# SPARTAN CHASSIS, INC.

RSB05-400-001B

## RECALL SERVICE BULLETIN

**SUBJECT:** Ametek NGI Air Pressure Dash Indicator Calibration

**FIG. 2-1**

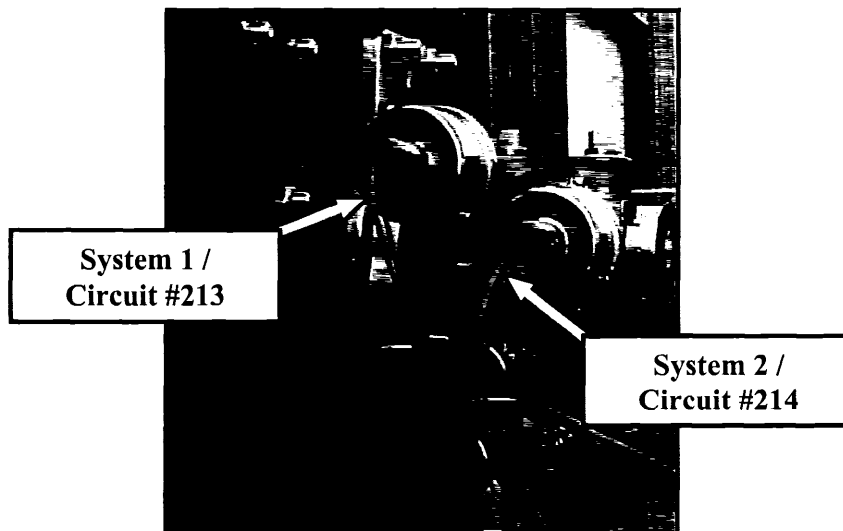
1. Observe all industry safety standards and secure vehicle to allow for disconnection of the air senders at to the front of the treadle assembly.

**NOTE:** Disconnect **ONLY ONE** sender at a time to ensure proper reconnection.

**FIG. 3-1**

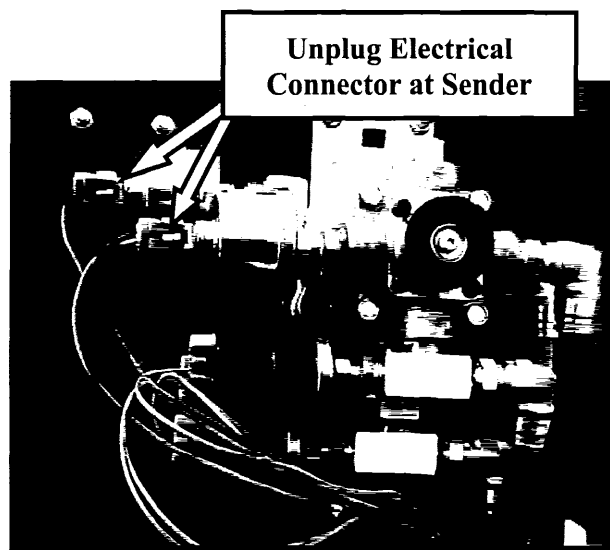
2. Refer to FIG. 3-1. Locate air senders at the front of the treadle assembly mounting plate.

3. Unplug electrical connector at one sender, plug one jumper harness from kit into the sender.
4. Plug electrical connector (previously unplugged from sender) into the jumper harness.
5. Repeat steps #3 and #4 for the remaining sender circuit.
6. Test the operation of the air pressure indicator in the dash.
